**Independent Investigation of the Catalyst  
Release from Martinez Refining Company on  
November 24-25, 2022**

Report prepared by  
Scott Berger and Associates, LLC

Version 3  
August 22, 2024

**Figure 1:** MRC’s Catalytic Cracking Unit

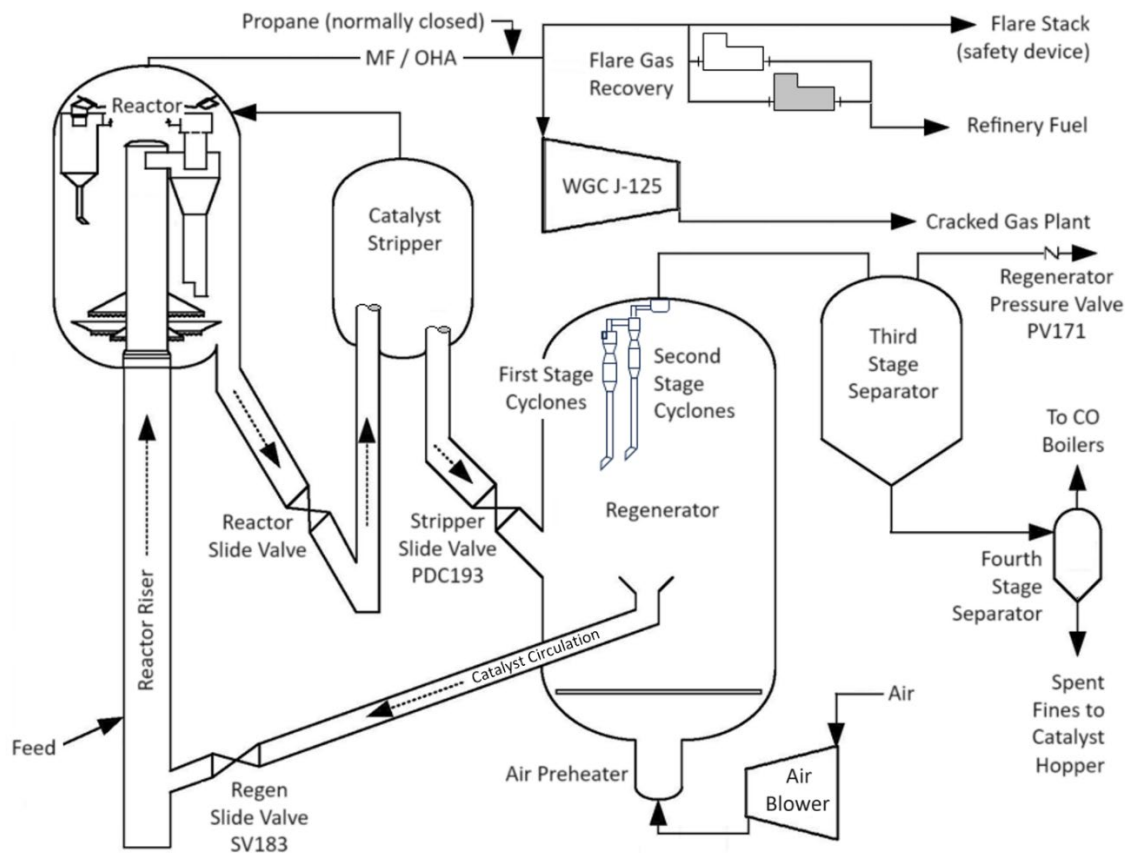
57	CCH Hazmat	CCH	Figure 1: Catalytic Cracking Unit, suggest adding MRC before Catalytic	Page 8		Thank you.	Done. See page 5 Figure 1 caption.
58	CCH Hazmat	CCH	consistently refer to WGC spillback control valve as such (in current draft this is stated as WGC or WGC spillback.	Pages 6 and 7		Thank you.	Done. Multiple changes on pages 8, 9, 10, and 15.
59	CCH Hazmat	CCH	"The vapor continues to the Main Fractionator (MF) where liquid products are separated, and the vapor is further cooled before being collected in the Overhead Accumulator (OHA)." Suggest adding HC before vapor	Page 8		Thank you.	Done. See page 6 paragraph 1.
60	CCH Hazmat	CCH	Figure 1: Suggest labeling air compressor as air blower for report consistency	Page 8		Thank you.	Done. See page 5 figure 1.
